NRC Inspection Report: 50-267/88-26

Facility Name: Fort St. Vrain (FSV)

Inspection Conducted: October 17-21, 1988

Areas Inspected: Reactive, announced inspection of the failure of the emergency diesel generator output breakers to automatically close during an October 11, 1988, test and a routine inspection of the instrument calibration program.

FIGURE 1

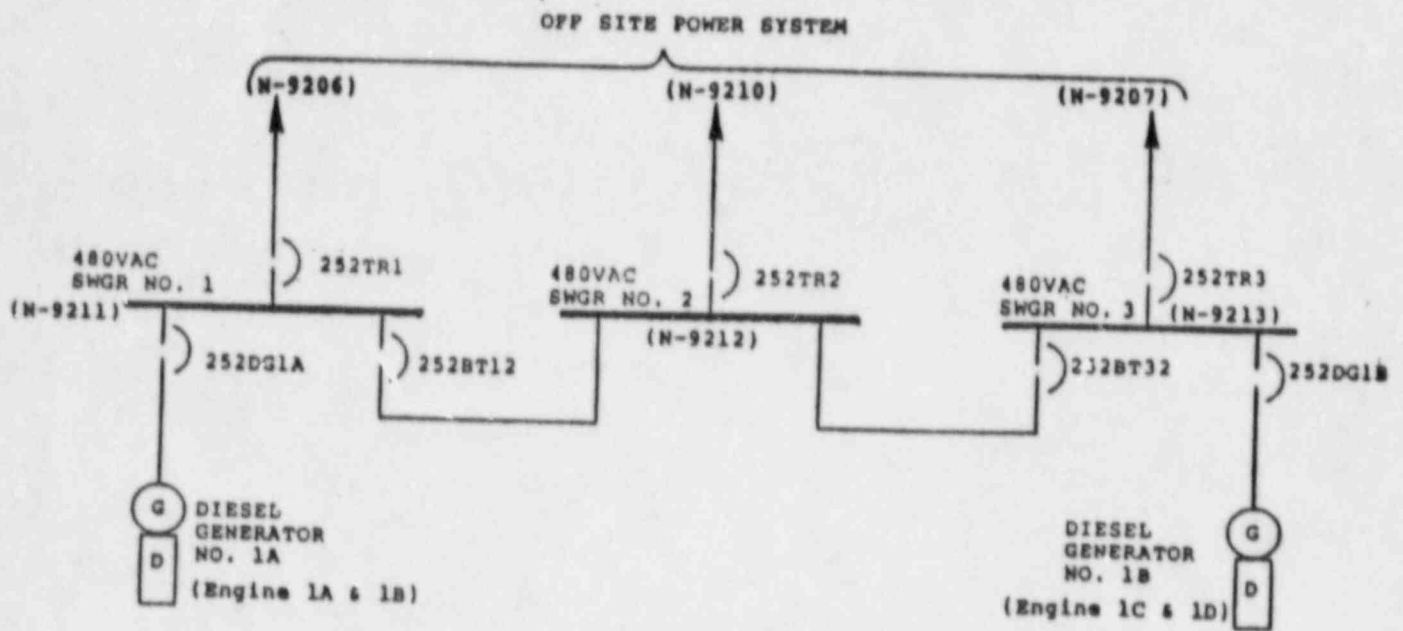
Relay CR-9203 (EDG 1A) or CR-9204 (EDG 1B) would be energized when its associated generator had both of its diesels running and the Timer T1, 1-second signal was present. The relay that was energized first (CR-9203 or CR-9204) would determine the generator that would supply power to two of the 480V buses; the other generator would supply power only to its associated bus when the 1-second time delay relay (TR-9202 for EDG 1B or TR-9201 for EDG 1A) times out. Relays TR-9201 and TR-9202 are energized when the opposite EDG's output breaker closes and auxiliary relays close a contact as the result of a two out of three undervoltage condition. Should relay CR-9203 be energized first, a trip signal is sent to bus tie breaker 252BT32 (Bus 2 to Bus 3) and a close signal is sent to bus tie breaker 252BT12 (Bus 1 to Bus 2) and EDG 1A output breaker 252DG1A. The opposite action would occur if CR-9204 were energized first, breaker 252BT12 would receive a trip signal and breakers 252BT32 and 252DG1B would receive a close signal.

During an LOSP test on October 11, 1988, EDG 1B duplicated functions were inhibited in accordance with SR 5.6.1e-1.5Y. When offsite power was removed from the feeders to the 480V bus, the feeder breakers (252TR1, 252TR2, and 252TR3) opened, and normal load shedding occurred. Both EDGs (all four engines) started and came up to rated speed and voltage within specification; however, neither EDG output breaker (252DG1A or 252DG1B) closed to energize the 480V buses. The bus tie breaker (252BT12) did close as expected.

The NRC inspector queried the licensee about the possibility of closing both bus tie breakers at the same time. In addition, the NRC inspector reviewed the schematic diagrams to evaluate the possibilities. The drawings show that an interlock prevents automatic closure of one bus tie breaker if the other is closed. In the case where both bus tie breakers are open, and both receive a close signal, additional provisions are present: (1) for an undervoltage condition on Bus 2, a selector switch (KS-92346) must be in either the Bus 1 position to close 252BT12 or Bus 3 for 252BT32; and (2) for automatic closure during an LOSP, relay CR-9203 provides the close signal to 252BT12 and a trip signal to 252BT32 if EDG 1A is the first available, or relay CR-9204 provides the close signal to 252BT32 and trip signal to 252BT12 if EDG 1B is the first available. It is possible to manually close both bus tie breakers at the same time, however, there is a synchronization interlock in the closing circuit for each breaker. This interlock is a normally open contact which is only closed when the single common handle is inserted in the selected circuit breakers' "sync-selector" switch and the switch turned to on. In addition to completing the interlock circuit, the syncroscope and synchronizing lights and meters are turned on. Therefore, the NRC inspector considered it very unlikely that both bus tie circuit breakers would be inadvertently closed at the same time.

Another concern over bus tie circuit breaker closure was the consequence of having the wrong breaker closed. As stated above, the selected EDG's closure relay (CR-9203 or CR-9204) provides a trip signal to the opposite tie breaker in addition to the DG output and associated tie breaker closure signals. Therefore, there would be no problem if a tie breaker was left closed or if a tie breaker was to close on undervoltage prior to the DG output breaker closure, assuming that the relays function properly (see LER 87-002 below).
